407.5.4

Required Egress from Smoke Compartments

904.14

1013.2

Egress from smoke compartments

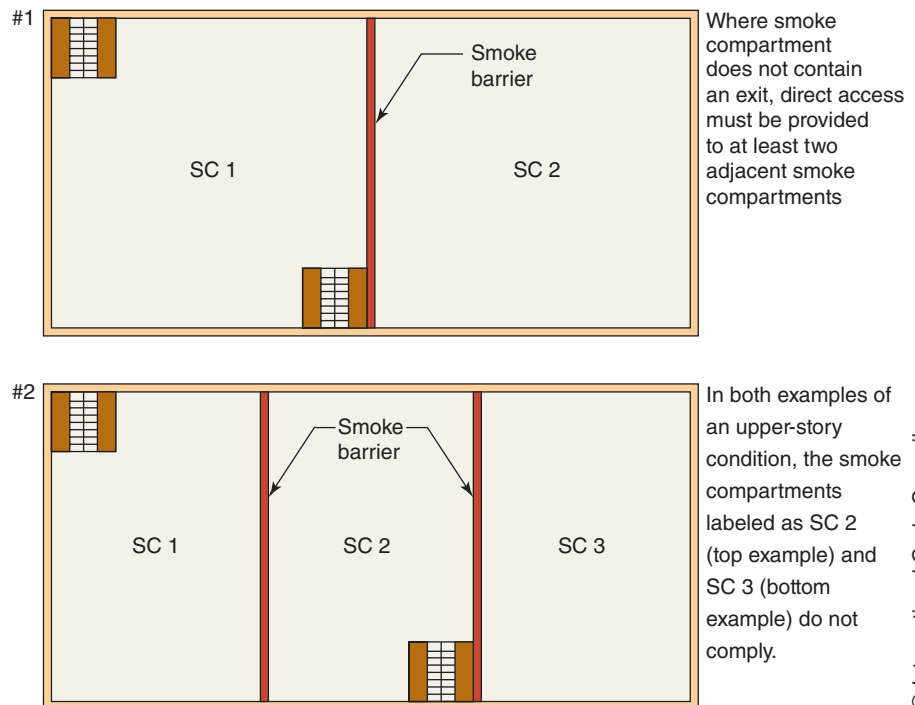
CHANGE SUMMARY: In Group I-2 occupancies, any smoke compartment that does not have an exit from the compartment must now provide direct access to a minimum of two adjacent smoke compartments.

CHANGE SIGNIFICANCE: In protect-in-place uses, such as hospitals and nursing homes, it is necessary to provide multiple smoke compartments to allow for movement of patients during fires and other emergency events. Previously, the only limiting requirement for a means of egress system from a smoke compartment was that the egress path could not return through the compartment of origin. An additional condition now indicates that any smoke compartment not having an exit must provide direct access to a minimum of two adjacent compartments.

Where there is no exit, such as a horizontal exit, interior exit stairway or exterior door at grade level, directly from a smoke compartment, the resulting condition creates somewhat of a “dead-end smoke compartment.” The IBC is now consistent with federal Medicare requirements in regard to the recognition of two alternative approaches to the design of the means of egress from a smoke compartment. Each compartment must be provided with a minimum of one direct exit, or direct access to at least two smoke compartments is required.

2018 CODE: 407.5.2 407.5.4 Independent egress. A means of egress shall be provided from each smoke compartment created by smoke barriers without having to return through the smoke compartment from which means of egress originated. Smoke compartments that do not contain an exit shall be provided with direct access to not less than two adjacent smoke compartments.

Low-level exit sign

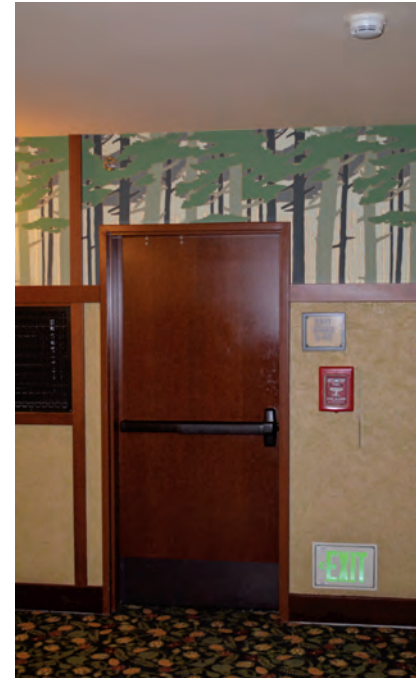
CHANGE SUMMARY: The permitted location for low-level exit signs selectively required in Group R-1 occupancies has been expanded to now allow the bottom of such sign to be mounted up to 18 inches above the floor.

In the 2015 IBC, only a 2-inch tolerance was established for where the bottom of required low-level exit signs must be located. This 2-inch allowance was often challenging for designers and property owners due to field conditions or desired interior finish and trim. For example, several high-end resort properties have installed 12-inch-tall base boards in the exit access corridors of their hotels. The requirement for the bottom of the sign to be located within 10 to 12 inches above the floor level creates issues for these and similar facilities.

The bottom of the required low-level exit signs is now permitted to be located between 10 and 18 inches of the floor level. The additional 6 inches now available provides sufficient flexibility for designers and owners without adversely impacting the level of life safety of the occupants of the Group R-1 occupancies because the low-level exit signs will still be visible below the smoke layer from a fire (in the zone in which the occupants would presumably be crawling).

NFPA 101 *Life Safety Code* Section 7.10.1.6 permits the bottom of low-level exit signs to be installed between 6 and 18 inches above the floor level. Therefore, there is another life safety standard that permits the bottom of low-level exit signs to be installed up to 18 inches above the floor level. Although NFPA 101 permits the bottom of the low-level exit signs to be just 6 inches above the floor level, the IBC retains the requirement for a minimum of 10 inches above the floor level because ICC A117.1 Section 404.2.9 requires door surfaces within 10 inches of the floor to be a smooth surface for the full width of the door. As low-level exit signs can be installed either on the wall or the door, it is important that the low-end limit be such that it does not conflict with accessibility requirements.

The bottom of the sign shall be not less than 10 inches (254 mm) nor more than ~~12 inches (305 mm)~~ 18 inches (455 mm) above the floor level. The sign shall be flush mounted to the door or wall. Where mounted on the wall, the edge of the sign shall be within 4 inches (102 mm) of the door frame on the latch side.
